Nº 155 Service Bulletin

SUBJ: FYI: Lockdown Assembly & Front Molding Change during the production of The Sopranos® Pinball and future Pinball Game Titles

Lockdown Assembly, Front Molding & Button Plug (Old Style)

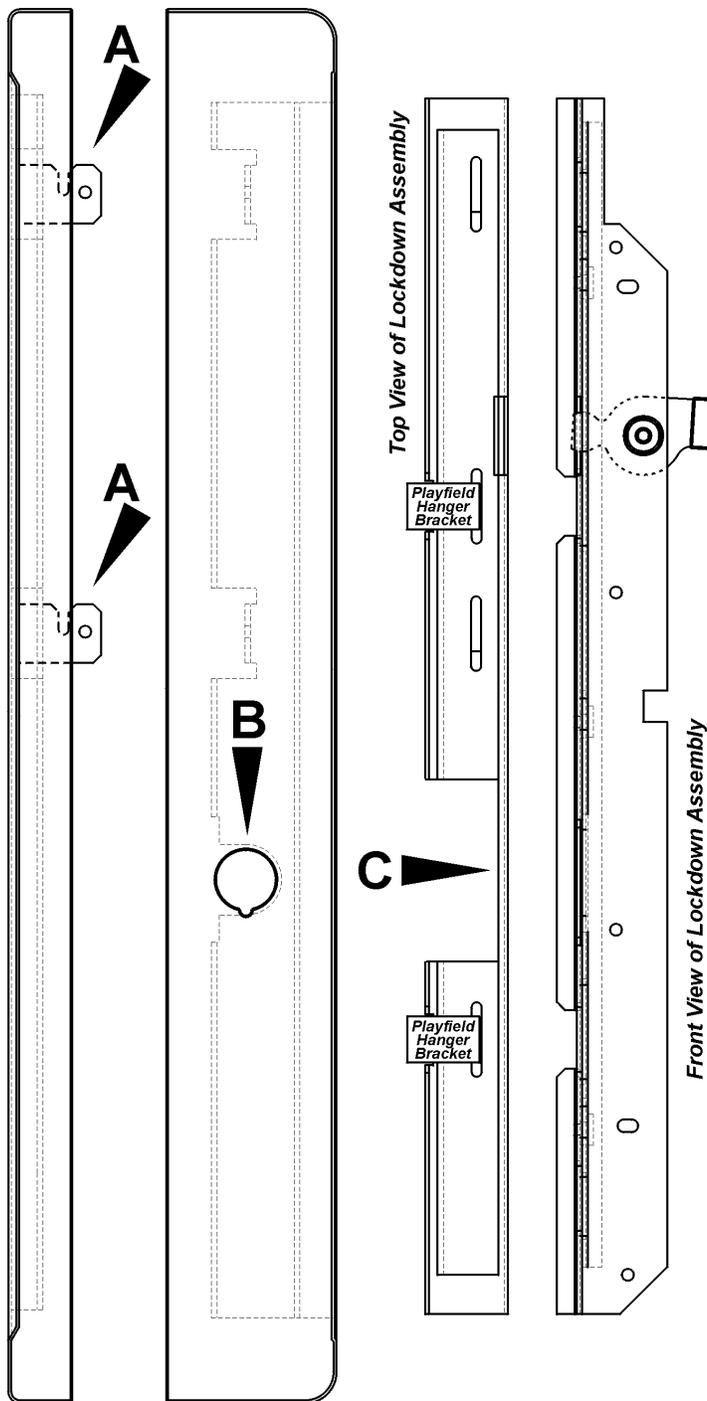
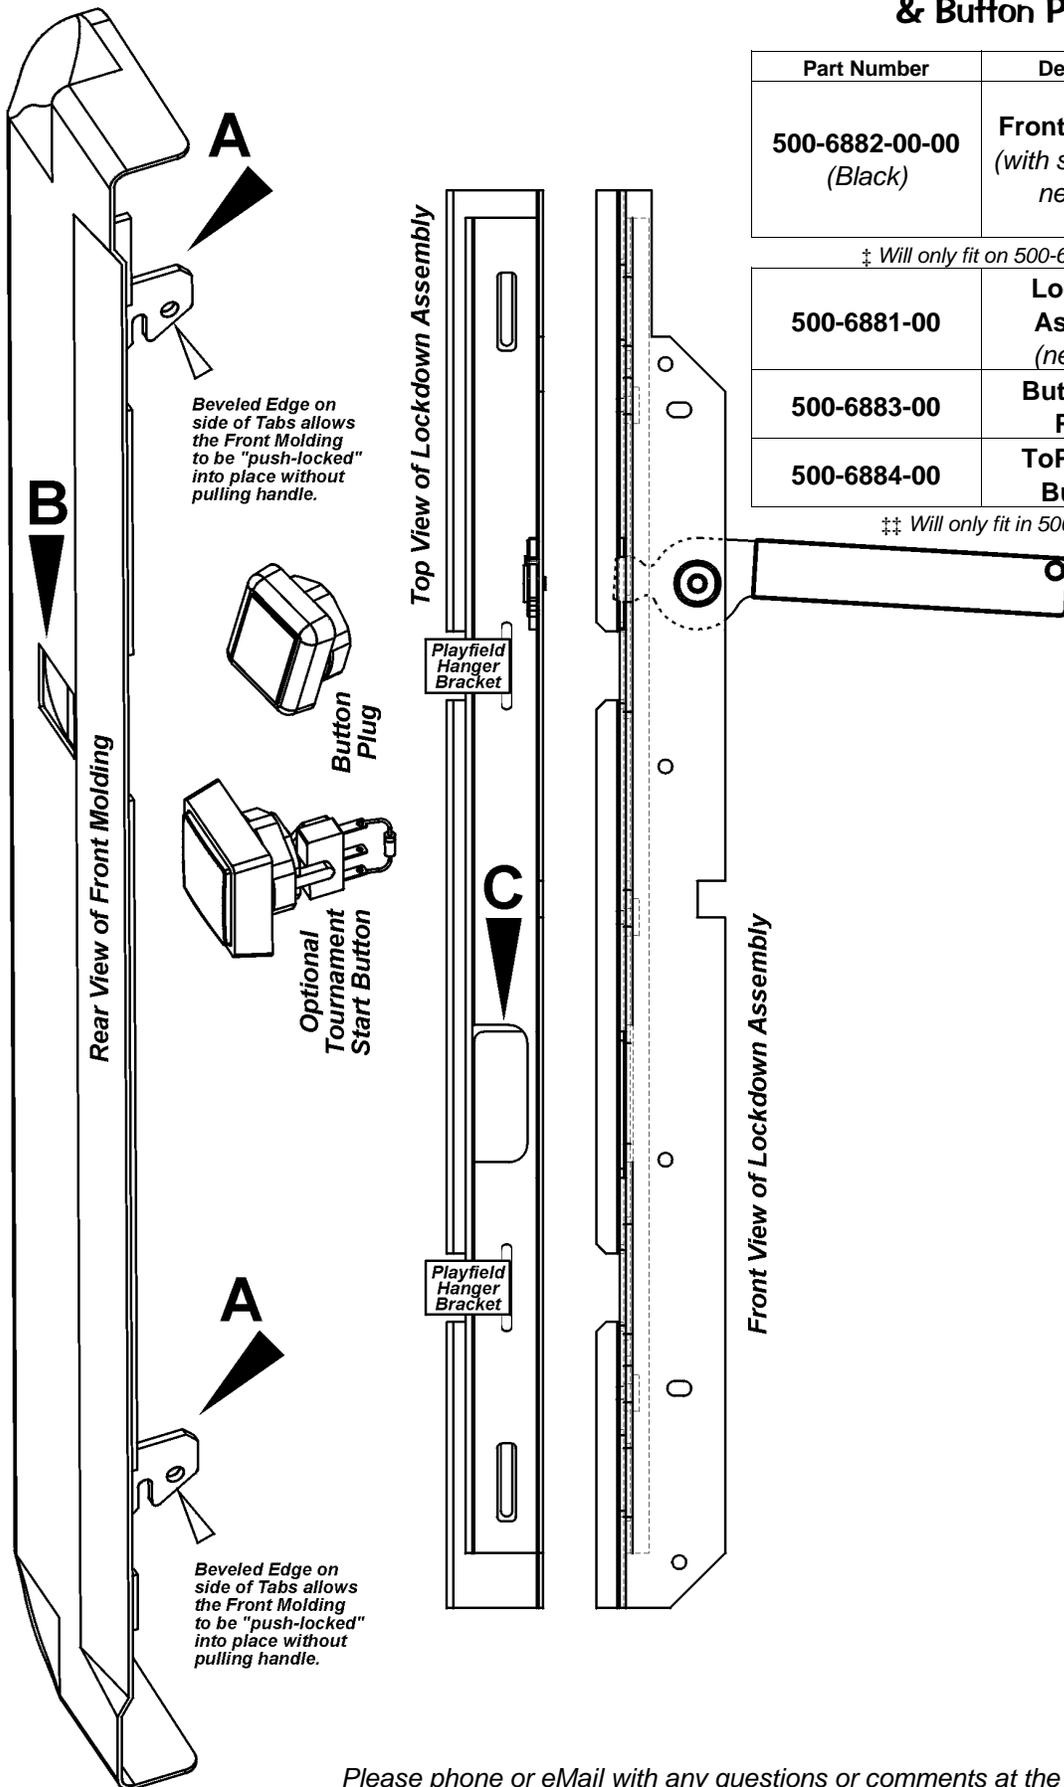
The Front Molding and Lockdown Assemblies are evolving. The ones shown on this page, which have been used many years on past games, are perfectly fine. The ones shown on the next page are the new styles.

How to identify the differences between the **old style (this page)** and **new style (next page)** :

Part Number	Description	Identifying Points
500-5757-02-00 (Black)	Front Molding* (with round hole; old style)	A = 2 Tabs located at the right and near center. B = Button Hole Access is round with a notch.

* Will only fit on 500-6509-00 Lockdown Assembly

500-6509-00	Lockdown Assembly (old style)	C = Access Hole has large open end cut-out.
500-6566-00	Button Hole Plug**	Round Top
500-6587-06	ToPS™ Start Button**	Fits Round Button Hole

** Will only fit in 500-5757-style Front Molding

Lockdown Assembly, Front Molding & Button Plug (New Style)

Part Number	Description	Identifying Points
500-6882-00-00 (Black)	Front Molding ‡ (with square hole; new style)	A = 2 Tabs lo- cated at the left and right sides. B = Button Hole Access is square.

‡ Will only fit on 500-6881-00 Lockdown Assembly

500-6881-00	Lockdown Assembly (new style)	C = Access Hole no longer has an open end cut-out.
500-6883-00	Button Hole Plug‡‡	Square Top
500-6884-00	ToPS™ Start Button‡‡	Fits Square Button Hole

‡‡ Will only fit in 500-6882-style Front Molding
